RE: Docket No. SPU-2021-0015

On November 22, 2021, Interstate Power and Light Company (IPL) and Preston Municipal Utilities (PMU), filed a Joint Petition for Adjustment of Service Territory (Petition). IPL and PMU jointly request that the existing electric service territory boundary lines be moved from their current locations to represent the areas currently being served by IPL and PMU.

As part of Utilities Board (Board) staff review of the filing, an initial mapping of the proposed boundary modifications was performed. Attached to this staff letter is a map (Attachment A) that illustrates IPL and PMU's proposed boundary modifications. The proposed modifications have been placed as a layer on top of the Board's current mapping data.

IPL and Preston Municipal Utilities Proposed Adjustment of Service Territory

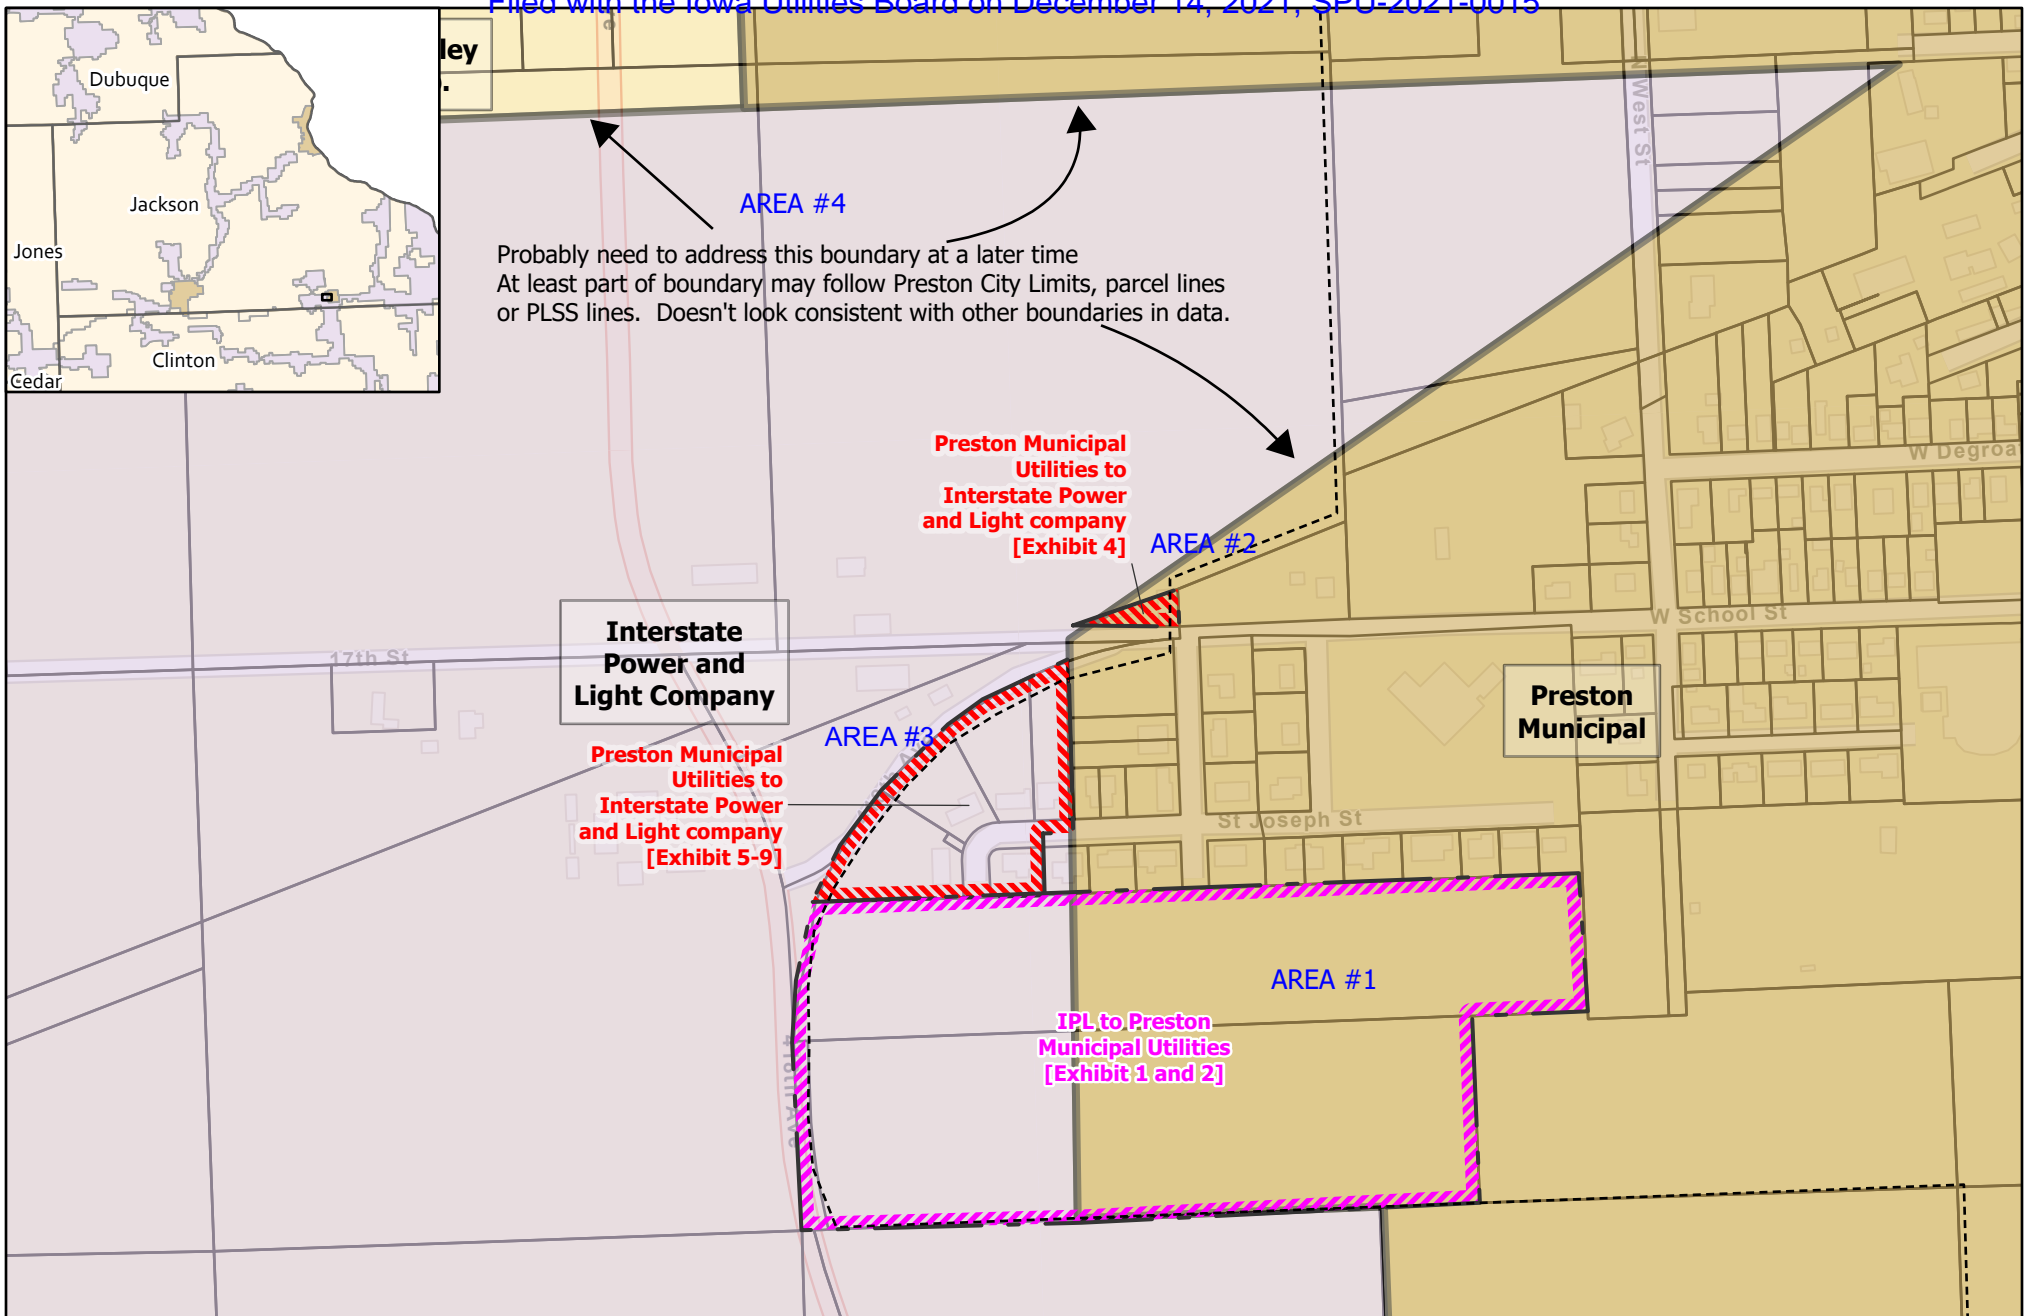
Staff has identified four areas (labeled in blue as "AREAS #1-4" on Attachment A) that show mapping data inconsistencies when comparing IPL's and PMU's mapping data against the Board's mapping data.

As proposed in the Petition and supporting documents, IPL and PMU mutually agree that PMU will serve the area marked by the dashed pink boundary line. The map shows that PMU (tan color) is already serving a portion of the service area proposed to be modified.

Explain this data discrepancy. Specifically, do the parties agree with the modification as proposed in Attachment A? If not, provide an explanation to the contrary.

As proposed in the Petition and supporting documents, IPL and PMU mutually agree that IPL will serve the area marked by the dashed red polygon. The map shows this dashed red polygon which will change from PMU (tan color) to IPL (lavender color).

Do the parties agree with this proposed modification as plotted in Attachment A? If not, provide an explanation to the contrary.

As proposed in the Petition and supporting documents, IPL and PMU mutually agree that IPL will serve the area marked by the dashed red boundary line. The map shows that IPL (lavender color) is already serving the area proposed to be modified.

Explain this data discrepancy. Specifically, do the parties agree with the modification a proposed in Attachment A? If not, provide an explanation to the contrary.

IPL and PMU filed a PDF aerial map labeled "Interstate Power and Light Company and Preston Municipal Utilities Electric Service Territory Realignment." This map shows elongated polygons that weren't identified by legal description/parcel information in the Petition or supporting documents.

Provide an explanation of this identified area. If the area identified is a proposed modification, provide the legal description/parcel information.
